Town of Hilton Head Island

Design Review Board Meeting

Tuesday, September 10, 2024, 2:30 PM

**1014 William Hilton
Parkway
PLAN SET**

SANCTUARY DEMOLITION PLAN

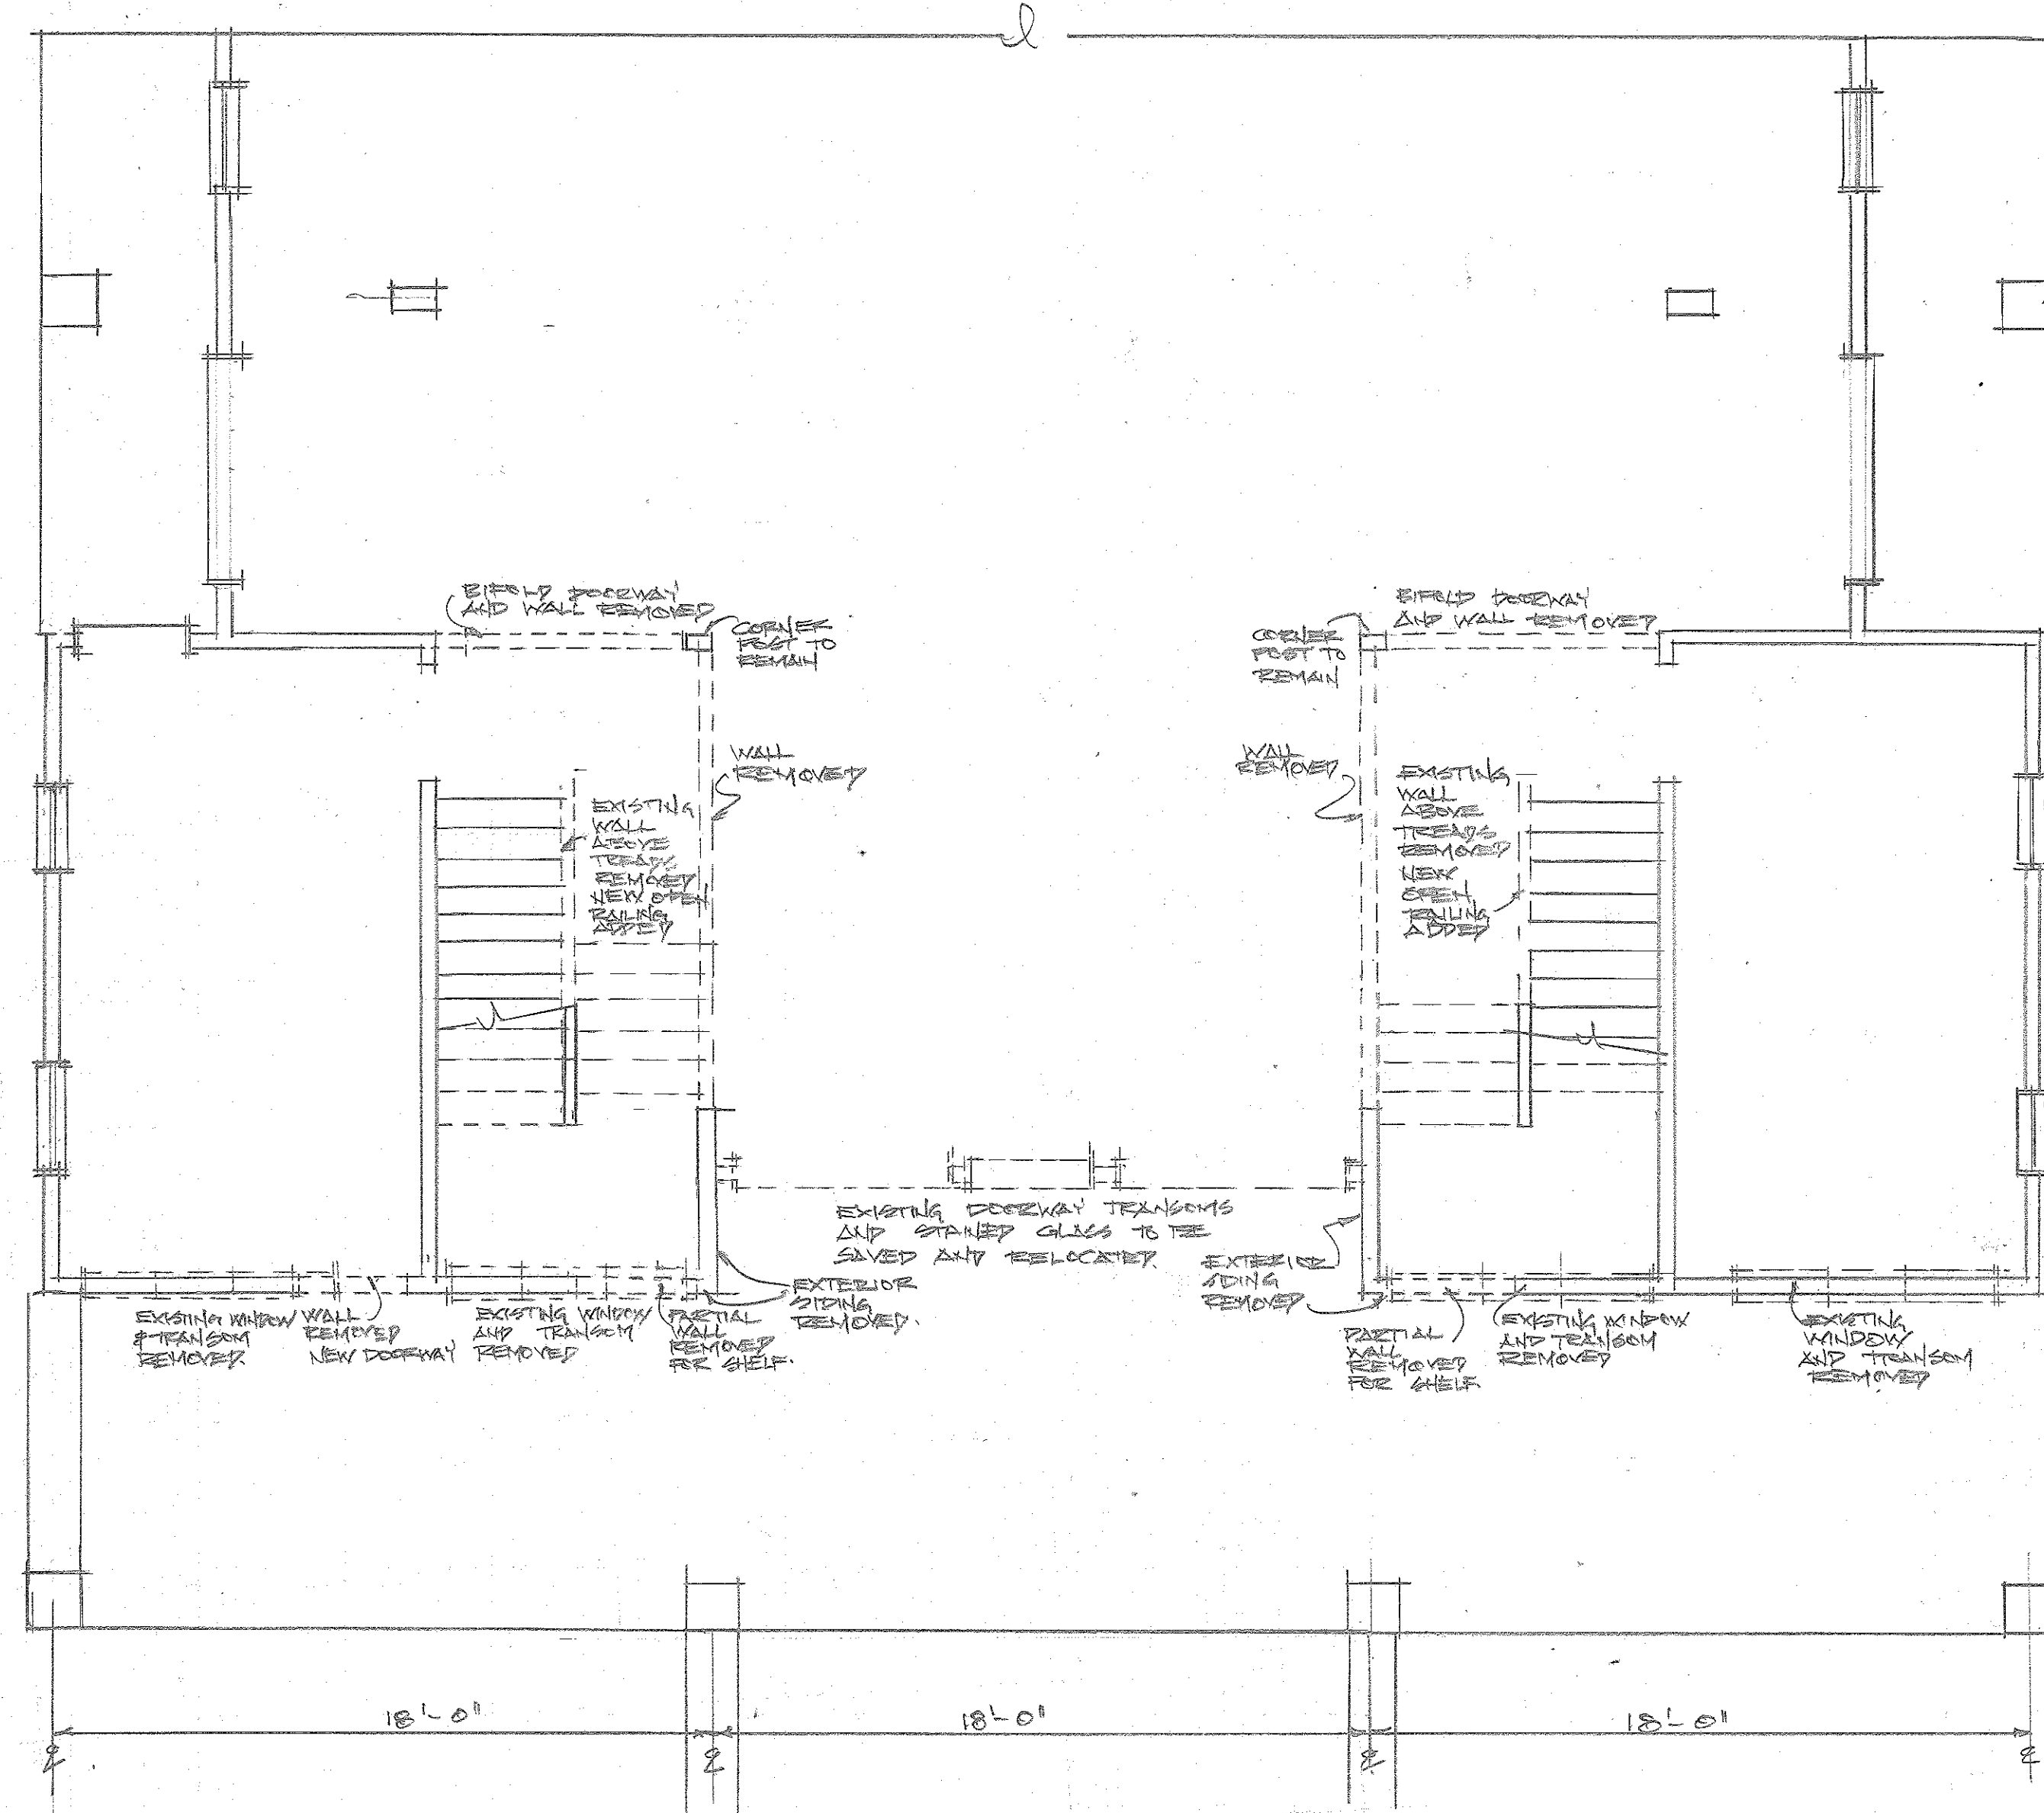
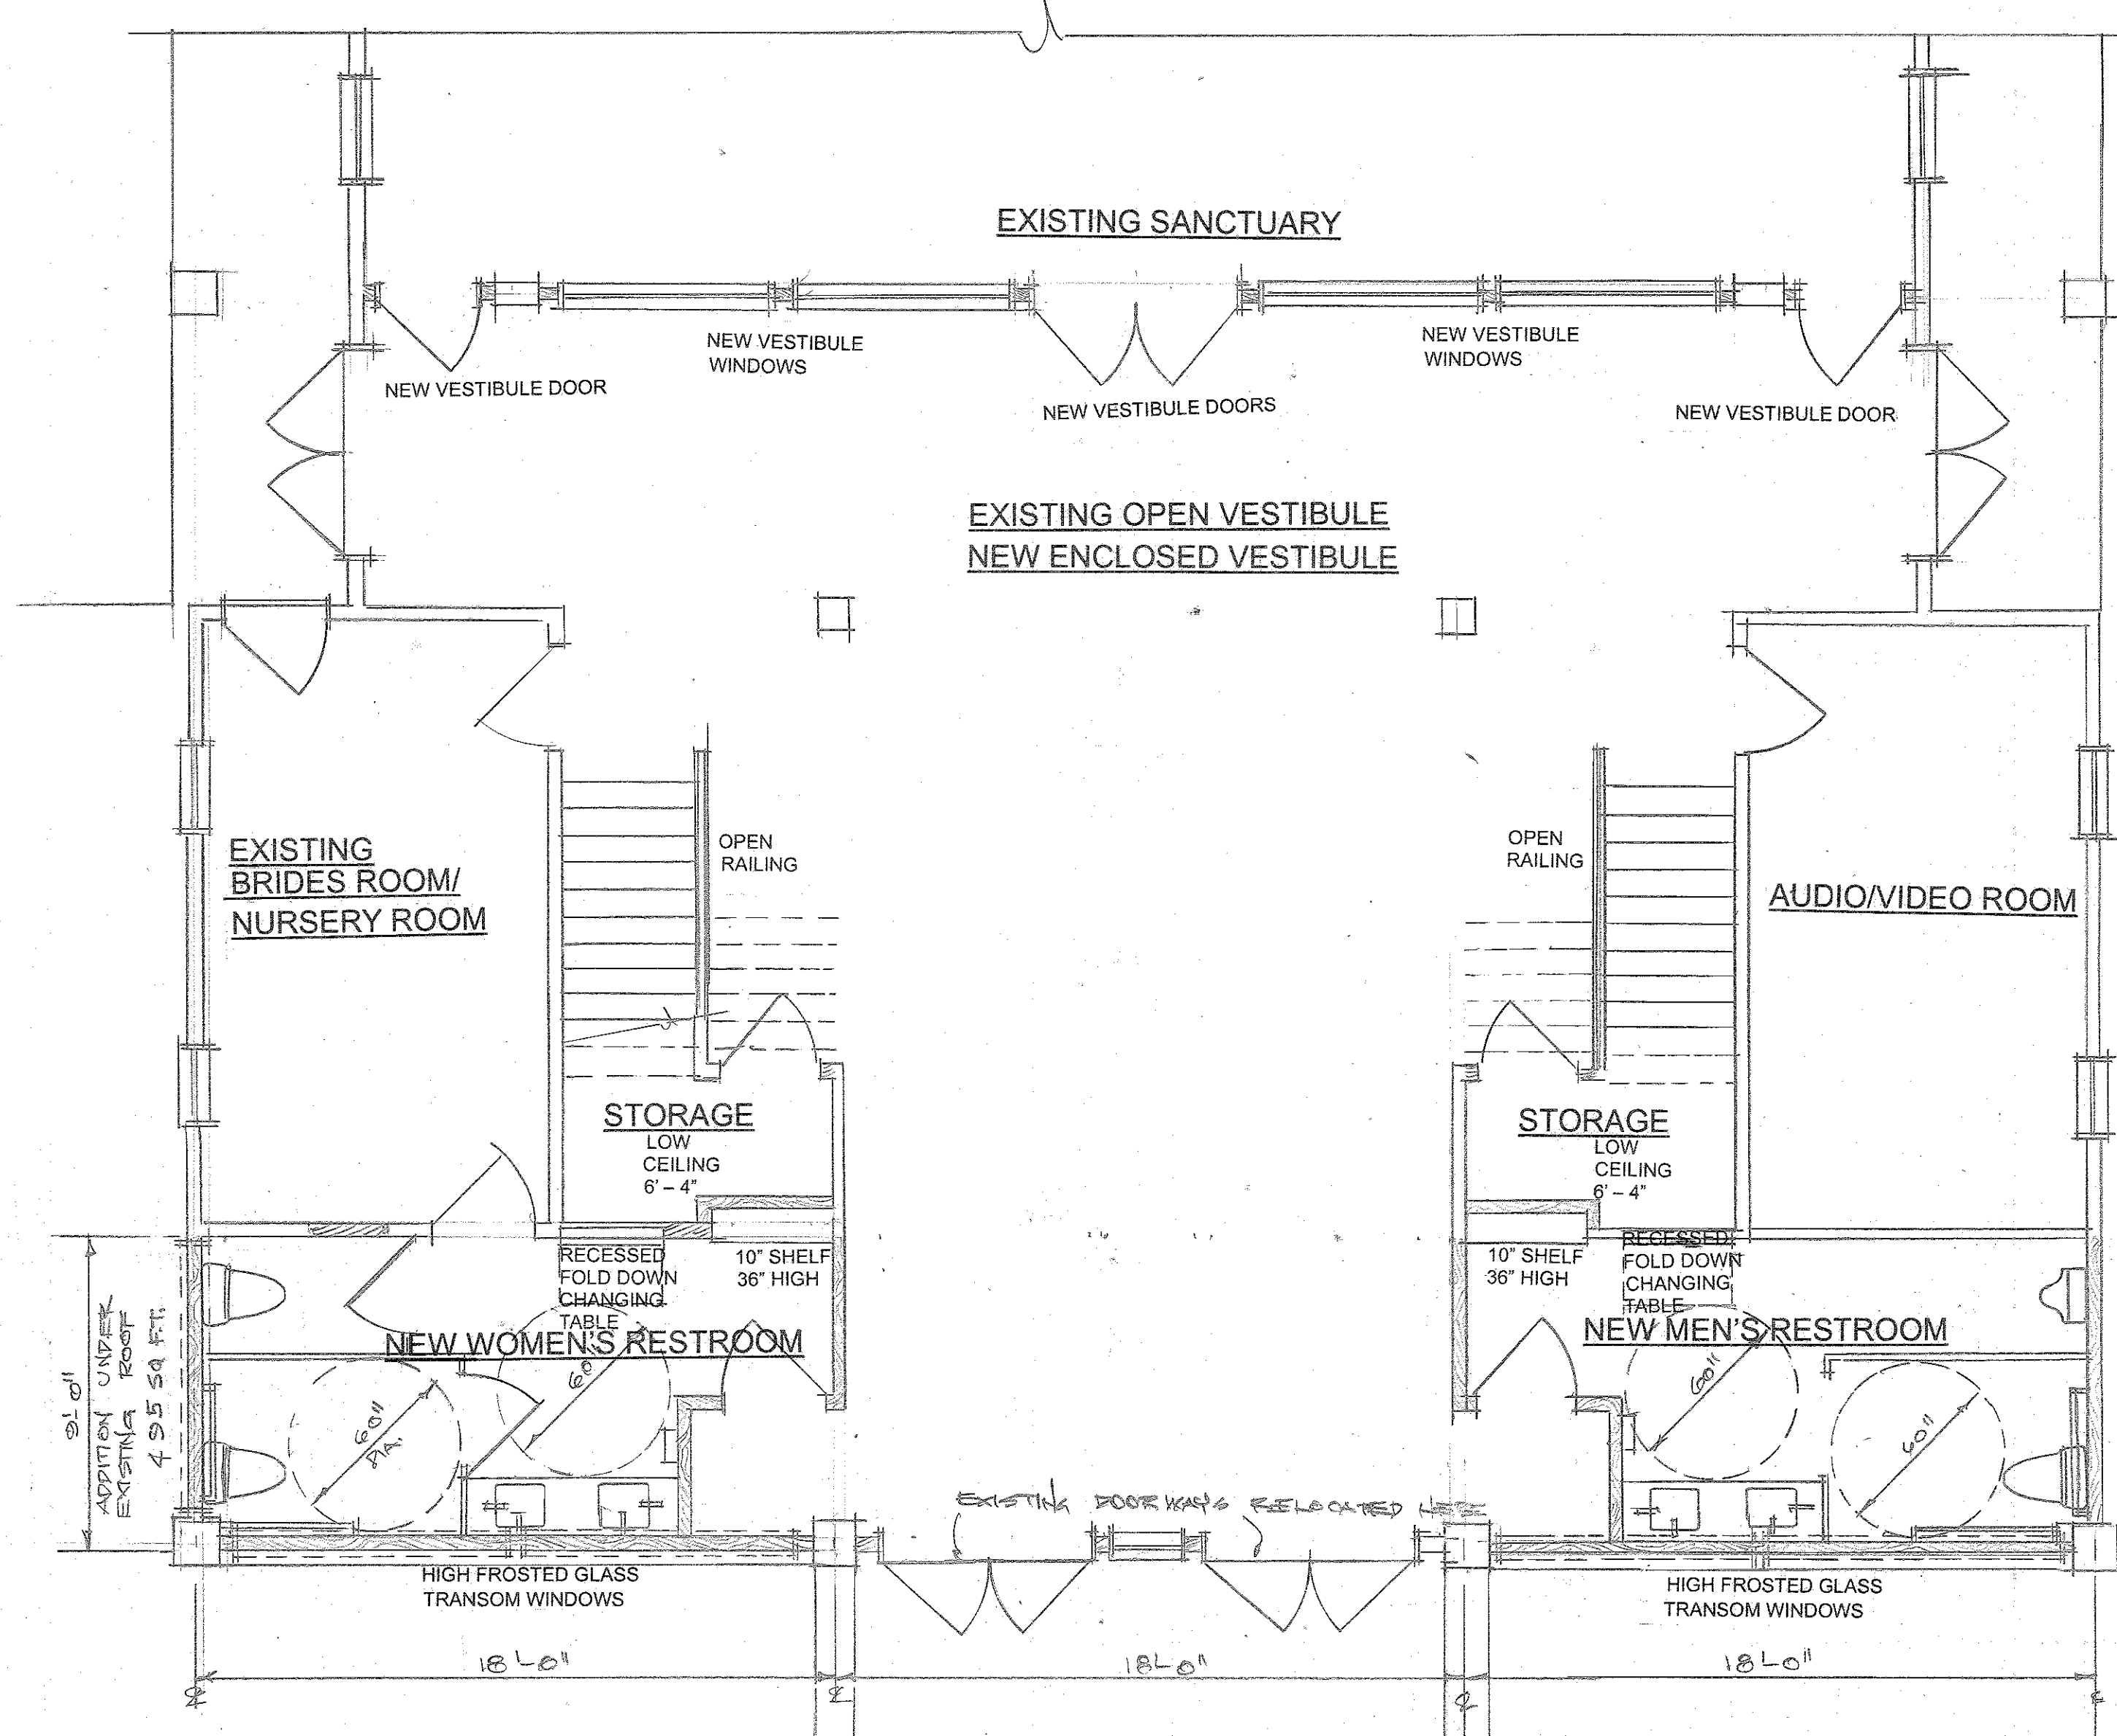
DRB REQUIREMENTS	Complies Yes	No	Not Applicable	Comments or Conditions
Demolition Plan if needed	☒	☐	☐	
Existing Conditions match As-Built	☐	☒	☐	The proposal is to construct bathrooms with A.D.A. handicap facilities for the church sanctuary.
Dimensioned Details and of Sections	☐	☐	☒	Provide dimensions on plans, elevations and sections for Final Review.
Detail Illustrating Connection to Existing Structure	☐	☐	☒	The proposed mural will be painted on an existing brick wall.
New Building Details Match Existing Building Details	☐	☐	☒

DESIGN GUIDE/LMO CRITERIA	Complies Yes	No	Not Applicable	Comments or Conditions
Structure is designed to be appropriate to the neighborhood	☒	☐	☐	
Promotes pedestrian scale and circulation	☒	☐	☐	
Design is unobtrusive and set into the natural environment	☒	☐	☐	
Utilizes natural materials and colors	☒	☐	☐	Provide a 11 x 17 Materials Board for final review.

Avoids distinctive vernacular styles	☒	☐	☐	
Design is appropriate for its use	☒	☐	☐	
All facades shall have equal design characteristics	☒	☐	☐	
Avoids monotonous planes or unrelieved repetition	☒	☐	☐	
Has a strong roof form with enough variety to provide visual interest	☒	☐	☐	
Overhangs are sufficient for the façade height.	☒	☐	☐	
Forms and details are sufficient to reduce the mass of the structure	☒	☐	☐	
Human scale is achieved by the use of proper proportions and architectural elements	☒	☐	☐	
Utilizes a variety of materials, textures and colors	☒	☐	☐	A 11x 17 materials board is required for final review.
Incorporates wood or wood simulating materials	☒	☐	☐	
Windows are in proportion to the facade	☐	☐	☒	
Details are clean, simple and appropriate while avoiding excessive ornamentation	☐	☒	☐	Provide details for final review.
Utilities and equipment are concealed from view	☐	☐	☒	
Decorative lighting is limited and low wattage and adds to the visual character	☐	☒	☐	Any exterior lighting for the bathroom addition shall be submitted for final review.

Accessory elements are designed to coordinate with the primary structure	☐	☒	☐	Provide any exterior elements of the addition to coordinate with the primary structure for final review.

LANDSCAPE DESIGN				
DESIGN GUIDE/LMO CRITERIA	Complies Yes	No	Not Applicable	Comments or Conditions
Treats the Landscape as a major element of the project	☐	☒	☐	Provide a landscape plan indicating the existing and proposed landscaping around the addition.
Provides Landscaping of a scope and size that is in proportion to the scale of the development	☐	☐	☒	
Landscape is designed so that it may be maintained in its natural shape and size	☐	☐	☒	
Preserves a variety of existing native trees and shrubs	☐	☐	☒	
Provides for a harmonious setting for the site's structures, parking areas or other construction	☒	☐	☐	
Location of existing trees and new trees provides street buffers, mitigation for parking lots, and an architectural complement that visually mitigates between parking lots and building(s)	☐	☐	☒	
Shrubs are selected to complement the natural setting, provide visual interest and screen less-desirable	☐	☐	☒

1. Staff recommends approval of the addition with the following conditions to be provided prior to the Final submittal:
 - a. Physical Material and Color Board on a 11”x17” - ask for example if needed
 - b. Provide dimensions on plans, elevations and sections.
 - c. Provide any lighting specs that will be used at the exterior of the addition.

| <ul style="list-style-type: none">d. If you are using exterior lights, provide a lighting plan for final review.e. Provide a landscape plan for any proposed planting around the exterior of the addition.f. Provide a Boundary Survey. <p>2. Any additional information as required by the Board.</p> |
